City of Rockwall, Texas

APPLICATION AND PRELIMINARY PLAT CHECKLIST

Name of Proposed Subdivision HARBOR LANDING I

PLAT REVIEW

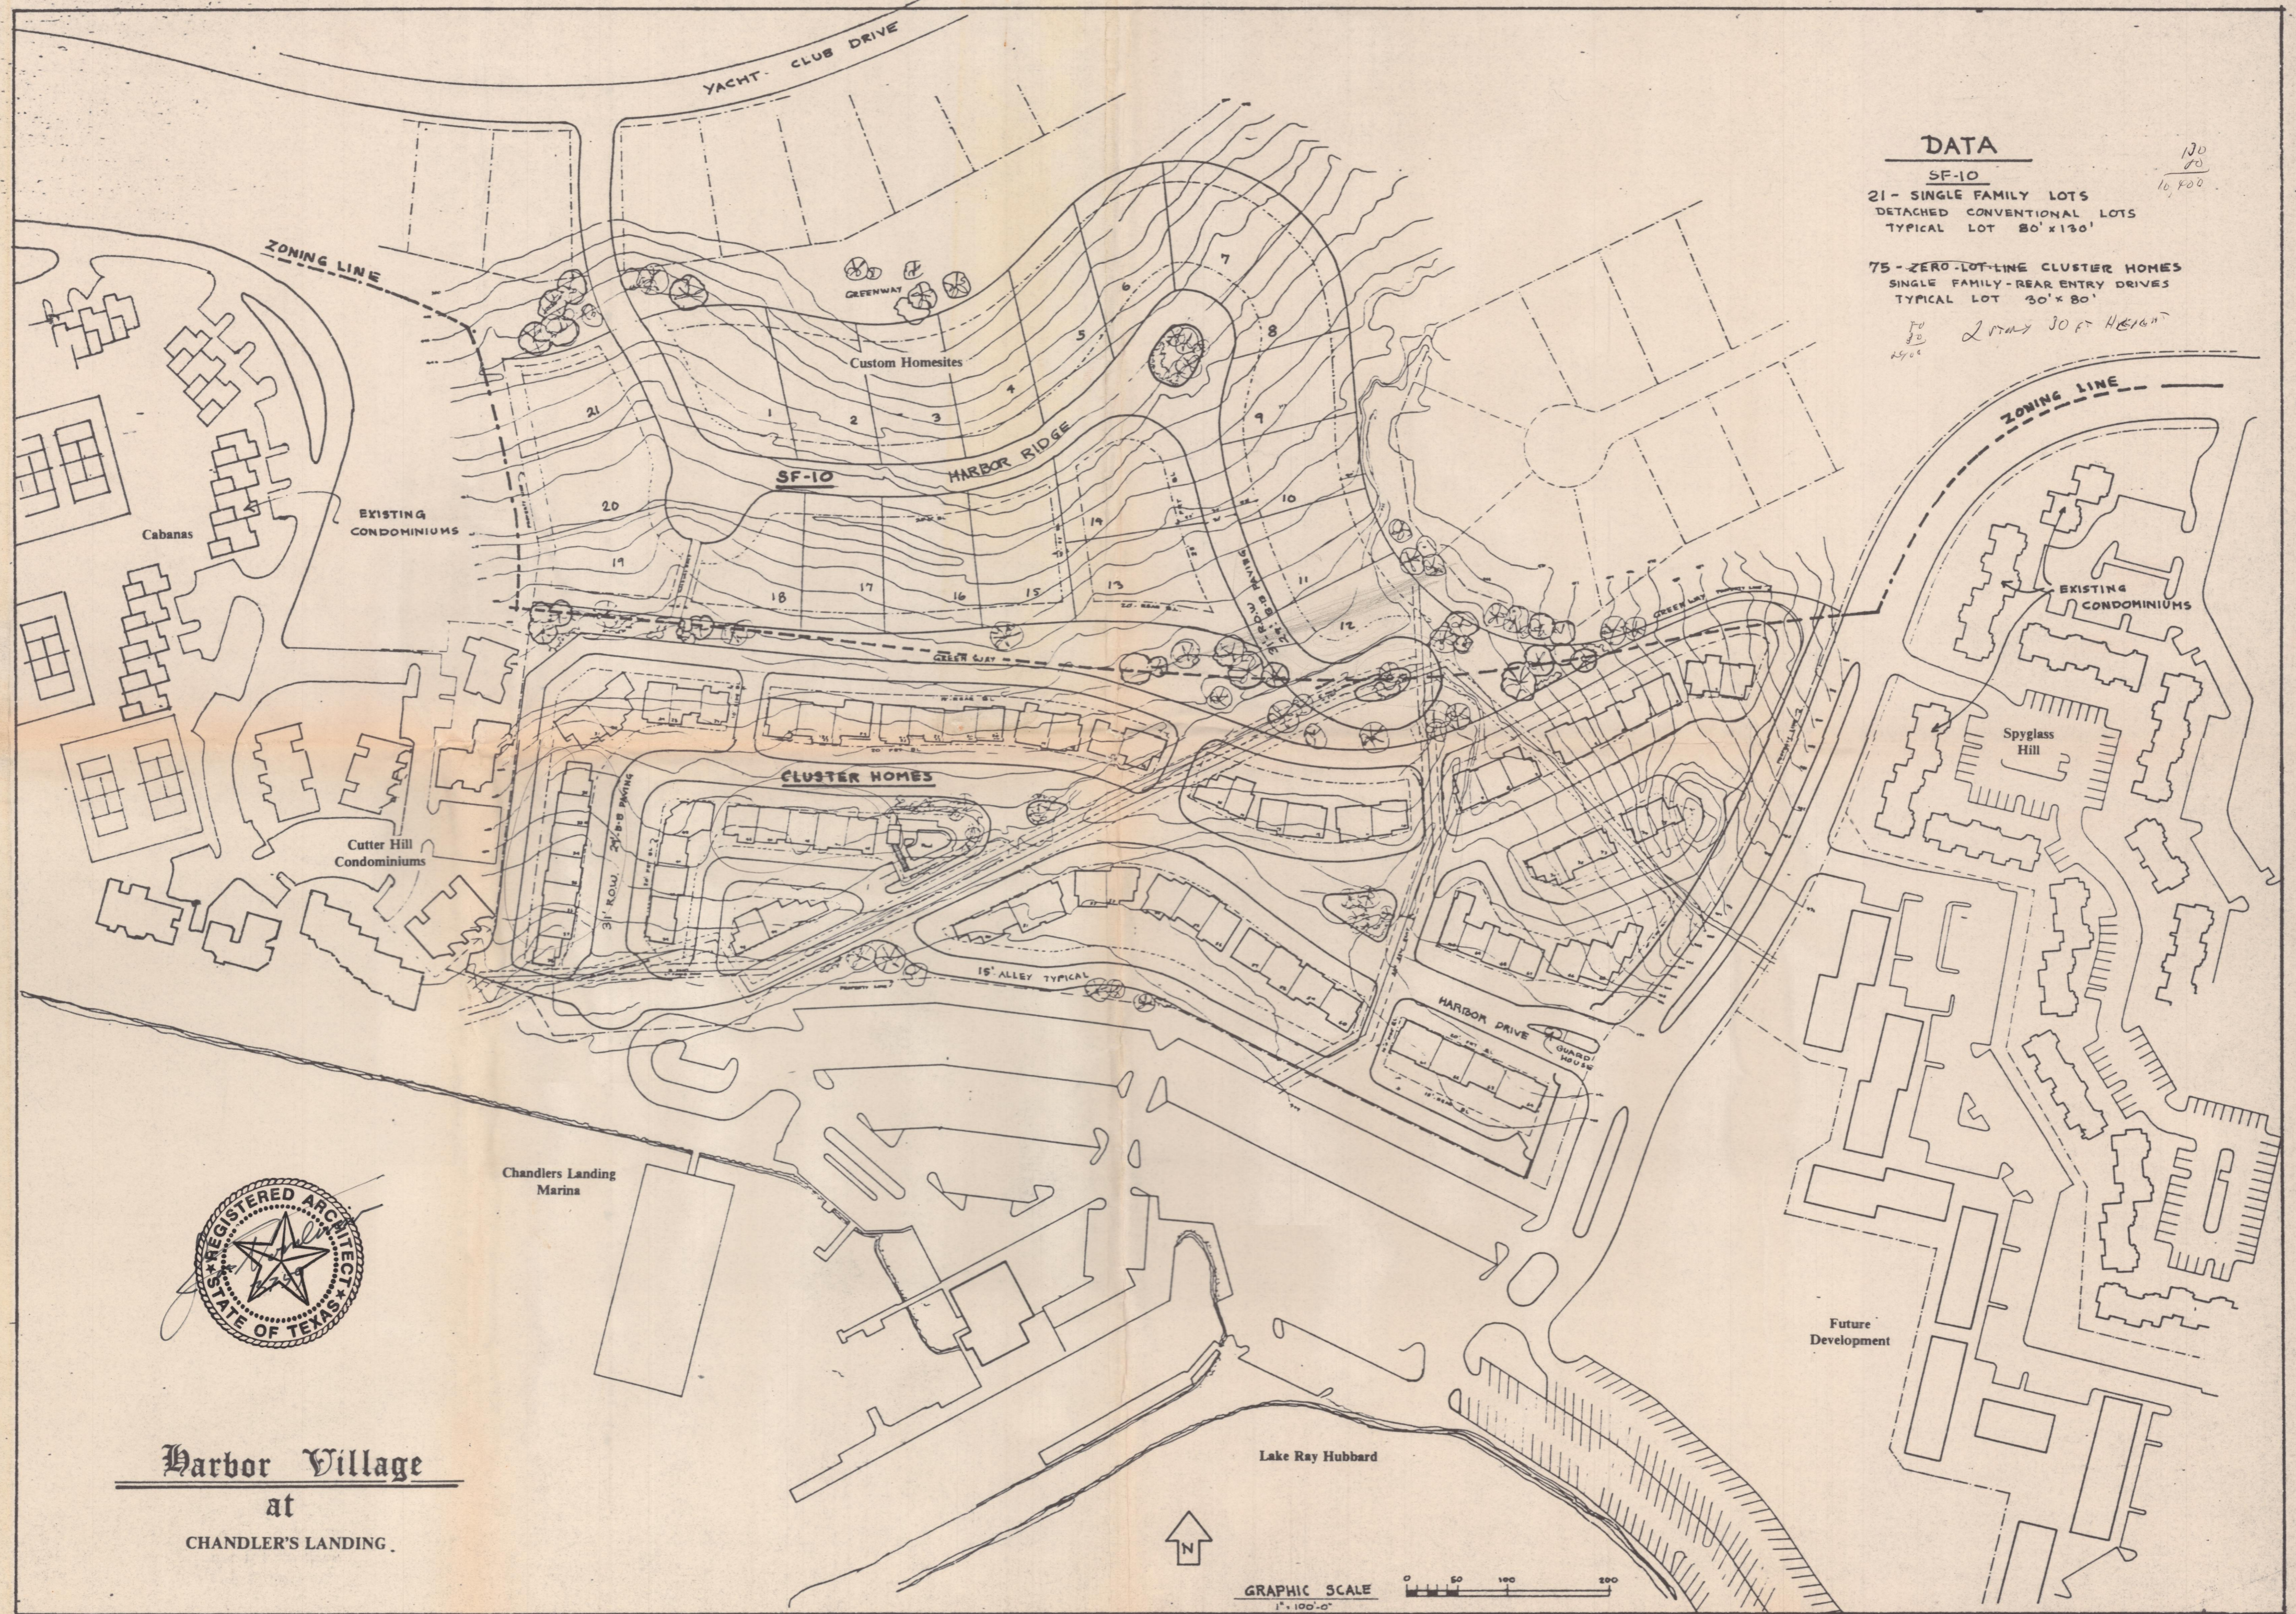
> On 12-3-85, the City Council voted to approve your request for the Preliminary Plat/Development Plan for a 21 single family lot subdivision in Chandlers Landing with the following conditions.

1. That the final plat must show details of all phases of 1-A as a total subdivision before approval of the final plat on Phase 1 will be considered.
2. The preliminary plat was approved as submitted to the Planning & Zoning Commission containing 21 lots and culdesac streets.

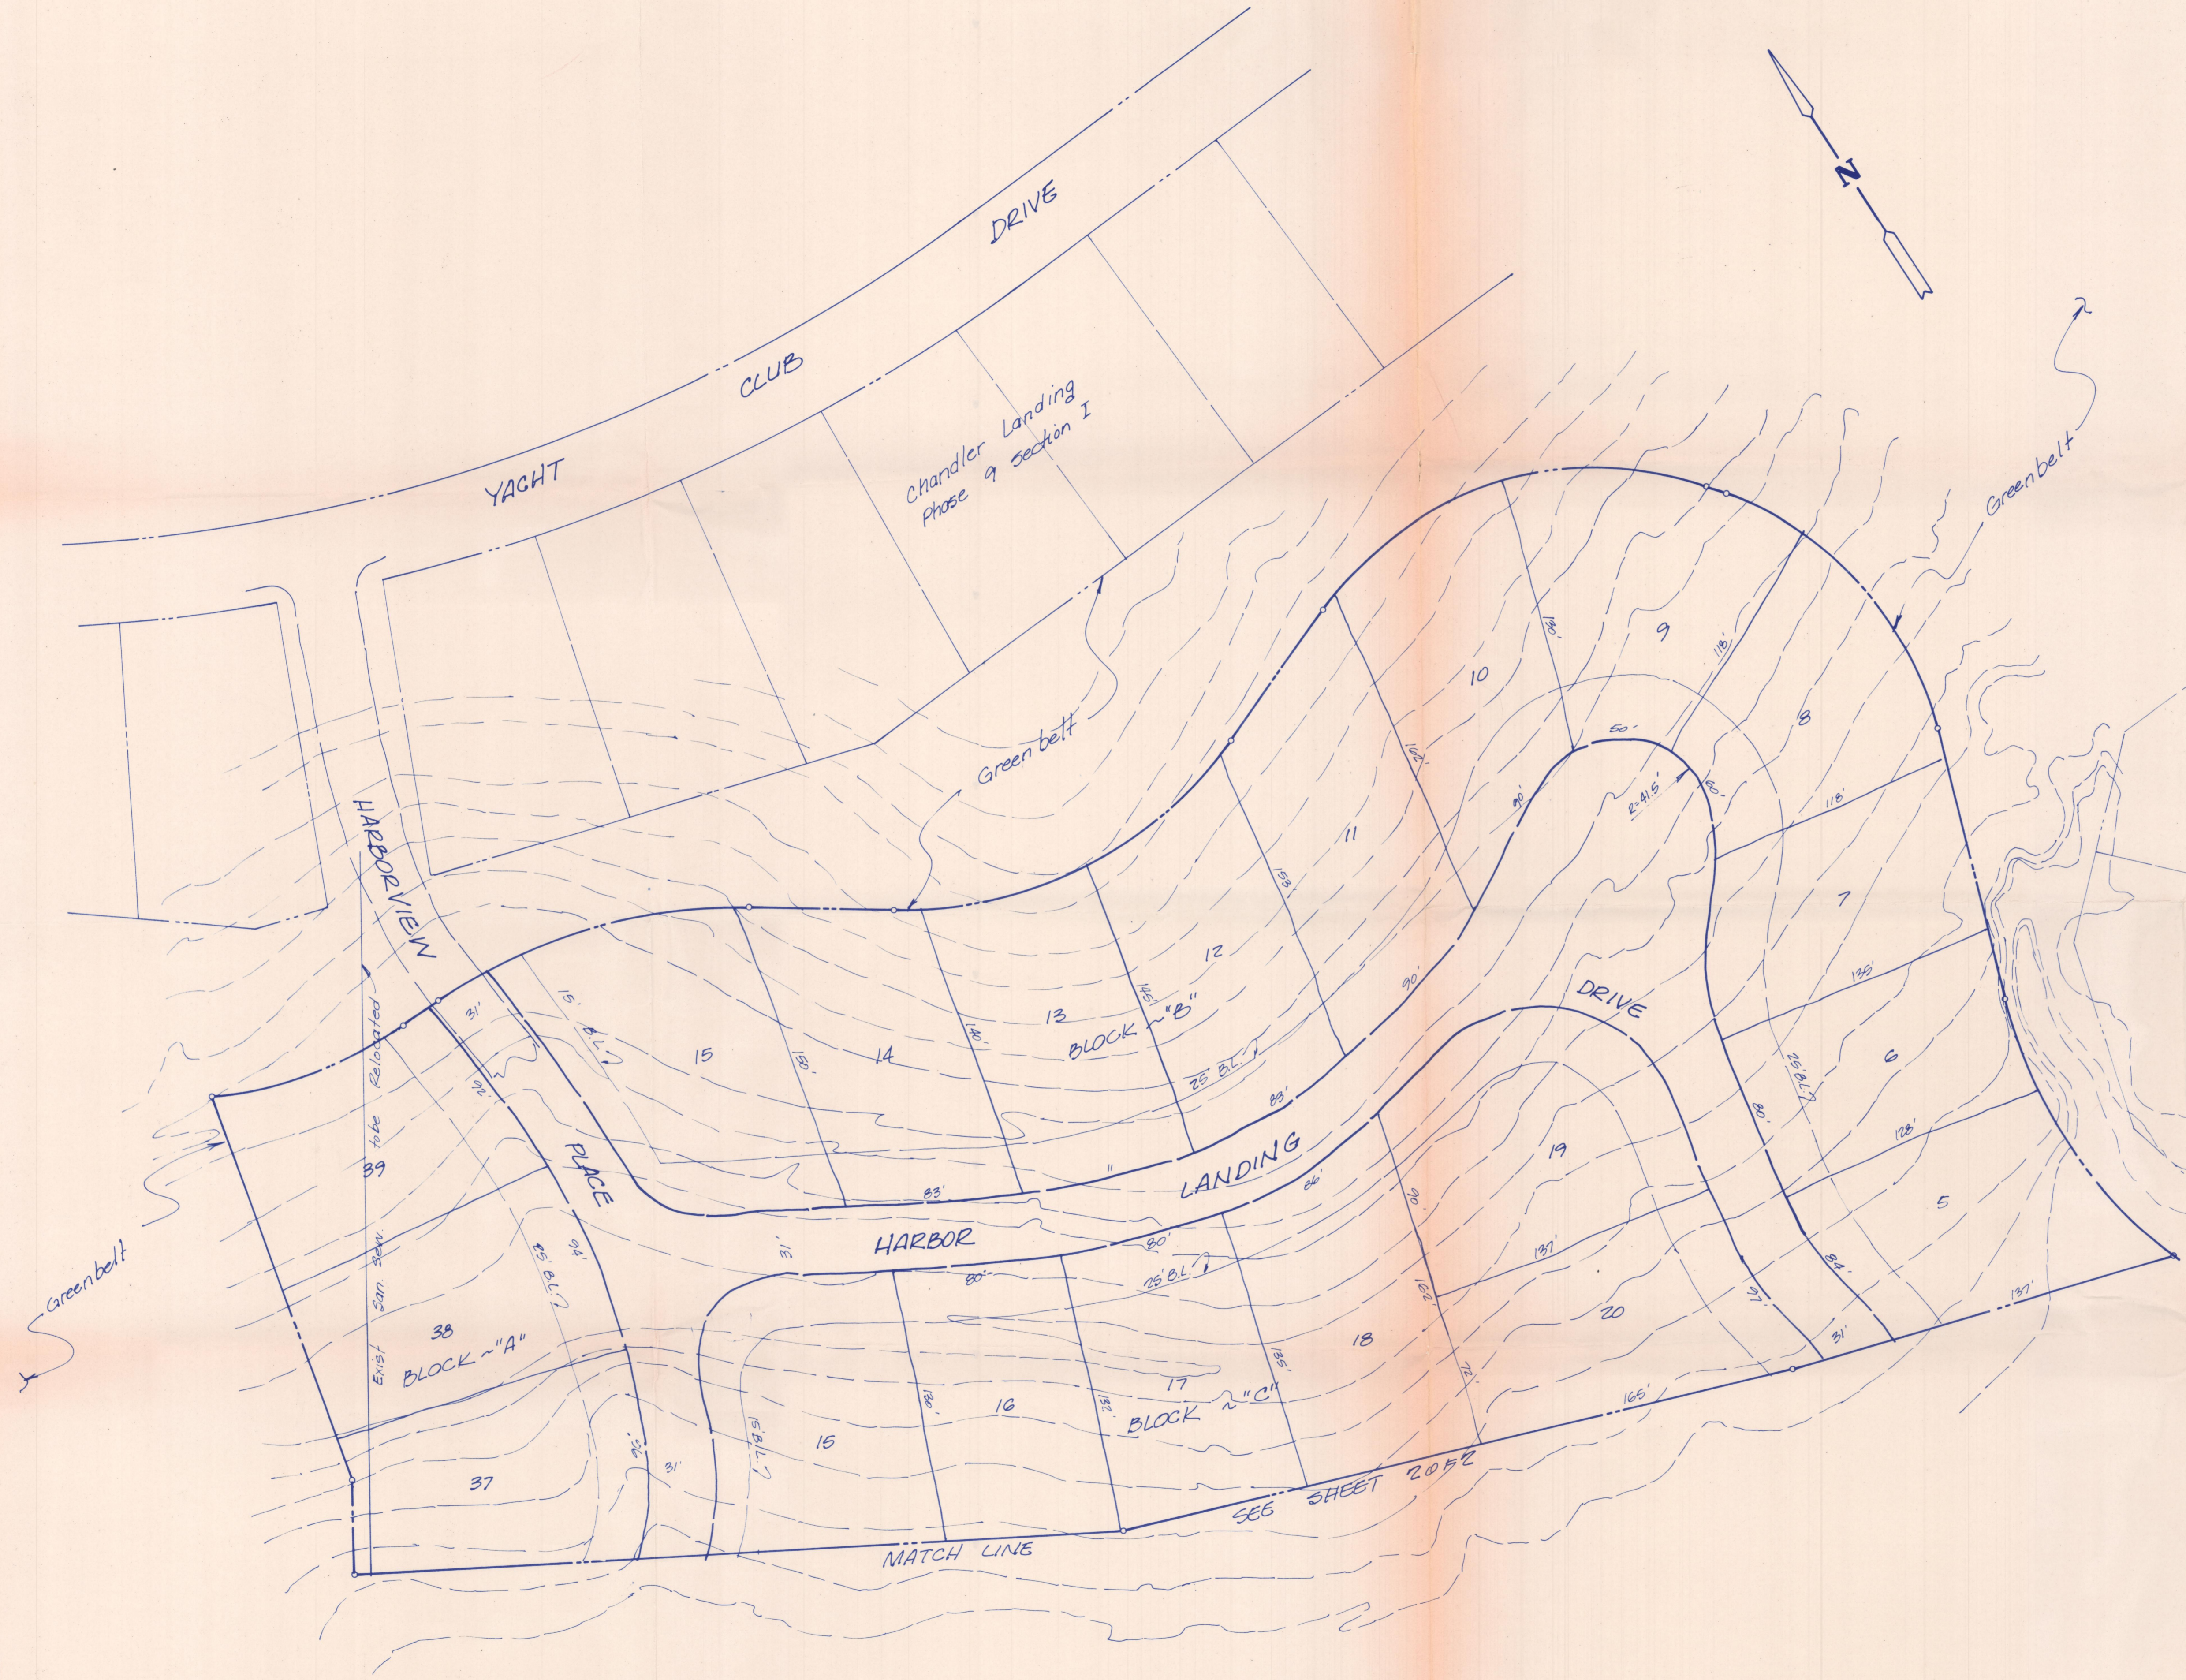
2nd submission  
forward plan to Council
